INTERNAL MEMORANDUM

SUBJECT: P/25/0294 - The Norton, Penydarren New vehicular access, creation of 6 units in the Norton, construction of two dwellings and landscaping and parking area within site.

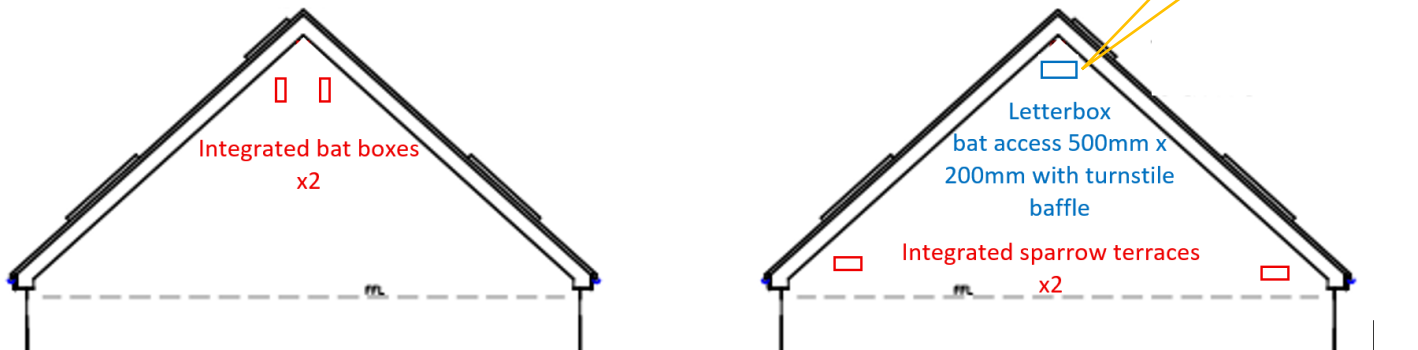
- o Document 1 states there will be x2 integrated bat boxes and x2 integrated sparrow terraces built into the new properties, however, Document 2 only shows one of each.

Also, the sparrow terrace is shown too close to the letterbox style bat opening on the northeastern gable.

Please amend the drawings as below.
